Technical Bulletin

Product: Greenstar 1000 Combi

INSPECTION AND REPLACEMENT OF THE BURNER DOOR SEAL

- 1) Silicone burner door seal (lip seal).
- 2) Burner door insulation pad.
- 3) Burner.
- 4) Electrode set.

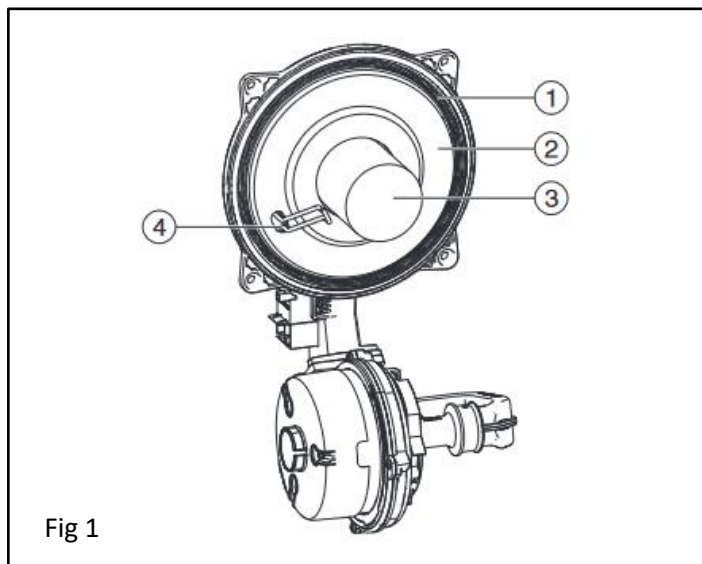
The current advice in the Installation and maintenance instruction manual for Greenstar 1000 Combi boilers advises that the burner door lip seal must be replaced if disturbed.

This advice has been revised to state that: “The silicone burner door gasket must be inspected at regular intervals. If it shows signs of damage, it must be replaced”.

Whenever the burner door is removed, the burner door seal must be visually inspected for any sign of degradation such as cracking. It should also be checked for any signs of hardening or embrittlement.

If there is any sign of such degradation, then the boiler must not be put back into operation until the burner door seal has been replaced.
